## Ulterra Updates

Since the release of Ulterra in early 2015 there have been a few minor design changes to improve some of the original components. These changes did not represent safety issues, but are an indication of an effort to continuously improve the reliability and performance of the Ulterra product line. **If the latest/current component part is not already installed then the installation of the current part(s) should be considered an “automatic” update:**

### Motor Ramp Plunger with Magnet Holder, p/n 2203700:

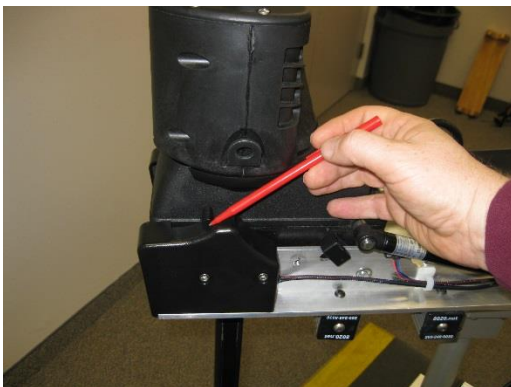
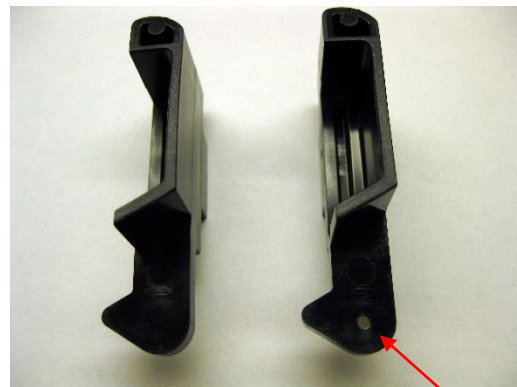
Beginning at serial number **P224MK** and later all magnet holders are using a mechanically staked-in process to prevent magnet loss. Verify Ulterra models with older serial numbers have the updated ramp plunger with staked-in magnet.

Original plunger on left. Current plunger on right.  
Notice that you can see the magnet through the pass-thru hole.

**Tilt Bracket Magnet Holder, p/n 2208600:**

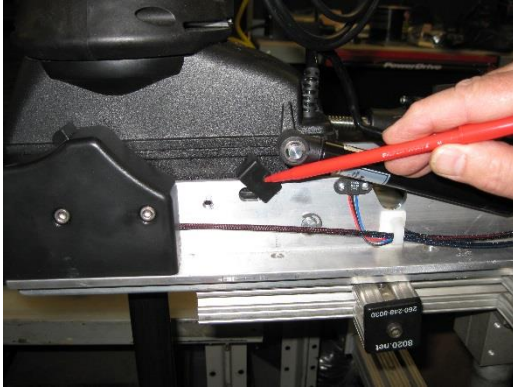
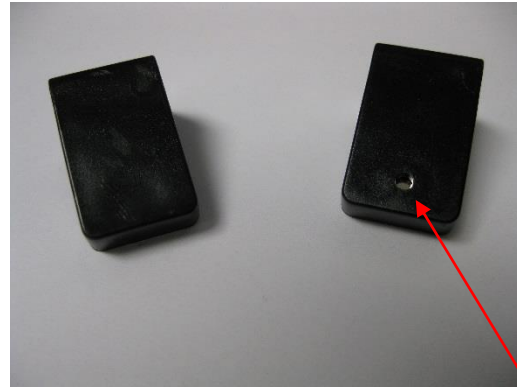
Beginning at serial number **P224MK** and later all magnet holders are using a mechanically staked-in process to prevent magnet loss. Verify Ulterra models with older serial numbers have the updated ramp plunger with staked-in magnet.

Original magnet holder on left. Current magnet holder on right. Notice that you can see the magnet through the pass-thru hole.

**Cam Sensor Arm with Magnet Holder, p/n 2777900:**

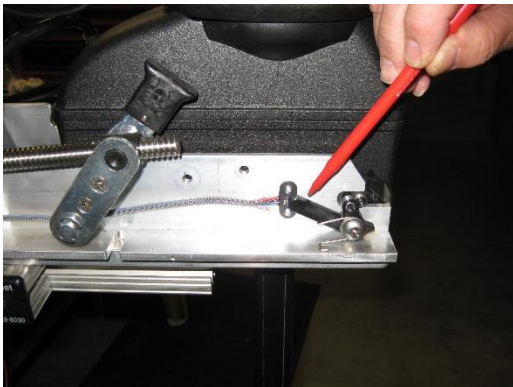
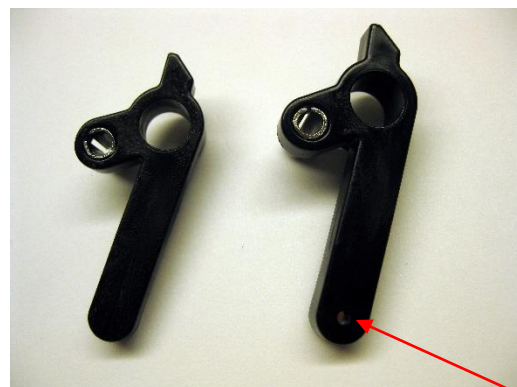
Beginning at serial number **P224MK** and later all magnet holders are using a mechanically staked-in process to prevent magnet loss. Verify Ulterra models with older serial numbers have the updated ramp plunger with staked-in magnet.

Original cam sensor arm on left. Current cam sensor arm on right. Notice that you can see the magnet through the pass-thru hole.

**Upper Belt Block with Belt Rack Kit, p/n 2882801:**

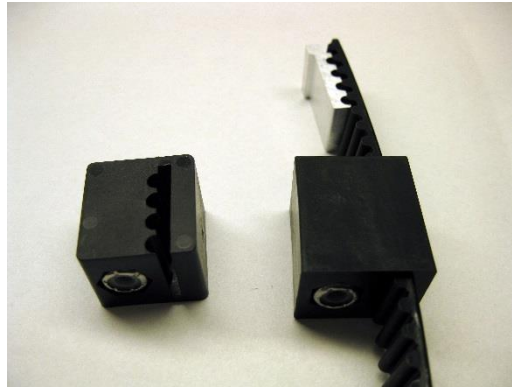
Beginning at serial number **P349MK** the upper belt block for tensioning the belt has been changed to a multi-piece design to lessen the chance of the belt pulling out of the control box. The original belt block, p/n 2202800, supersedes to p/n 2882801 which includes the belt rack.

Original belt block on left. Current belt block with belt rack on right.

(Original design had the belt sliding in from the side. The current design has the belt passing through the block and is retained with a metal belt rack.)
